## Rathburn/Ponytrail Integrated Project For Discussion: Meeting with City Staff

### **Objectives for this Meeting**

Our objective is to understand how this project got from a scheduled resurfacing and maintenance of roads and curbs to become an integrated project (IP), and to ensure our community that in doing so, the city and planners followed the appropriate steps and guidelines required to ensure safety and the environment were embraced.

### (ALTERNATIVE 3) - RATHBURN ROAD EAST (Ponytrail Drive to End of Cul-de-sac)

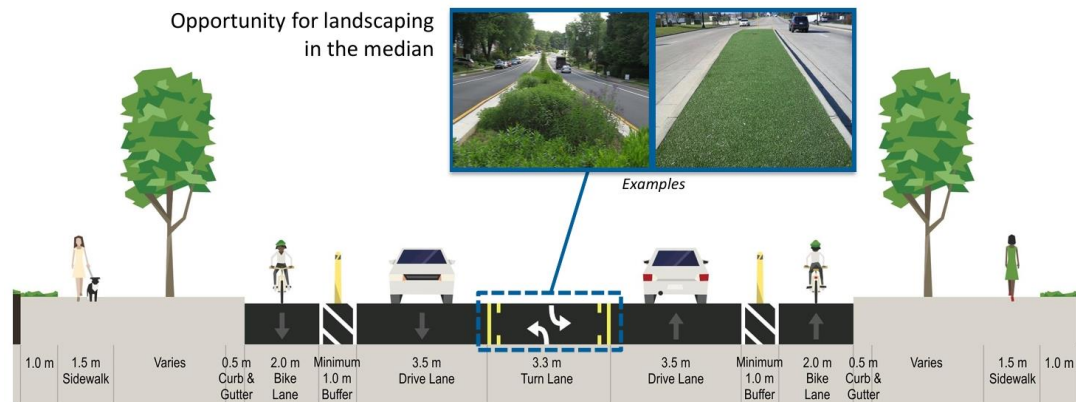
The preferred design on the 1<sup>st</sup> IP presentation was also the choice of the community. A similar design was presented at Pic 2. We expected the final design or a reasonable facsimile. Note that this diagram indicates the widths of each section of the road. Inset, behind the turn lanes, is what we believed was going to be installed as a boulevard in the centre of the road. Prior to the construction, this stretch of Rathburn was a relatively straight road. The design indicated in these presentations, and those posted on the website, support that the twists and turns implemented were done so without notification to those who would be affected.

The impression given the community in regards to the boulevard was false. While removing 2 lanes of the roadway, it was assumed that one lane would have become the bike path, which would be about 4 metres, in total.

**This statement is slightly inaccurate. In PIC 2, they completely changed the design. The analysis here is actually referencing a completely different option in the short list which was clearly shown in PIC 1 as being a lower desirability and not meeting criteria. This option was actually red. I think I sent an email to the rockwood email highlighting this and how it changed. Use that for this section.**

Q. Considering the diagram above allowed 2 meters for the bollards, was this space added to the roadway? If not, where was it allocated?

Q. The design allocated 4 meters for a bike lane, which is .5 meter larger than a traffic lane. The bollards were not used, therefore there should have been existing space for the equivalent of another lane which would have accommodated a much wider boulevard and/or larger lanes. How was this space used?

Q. The designs never showed any accommodation for drainage ditches, yet there is a large section of the road on the south side allocated for a swale. When was this added? Why was it not put underground?

**Why was this not included in the PIC or option analysis if it is clearly a major component of the design configuration of the road?**
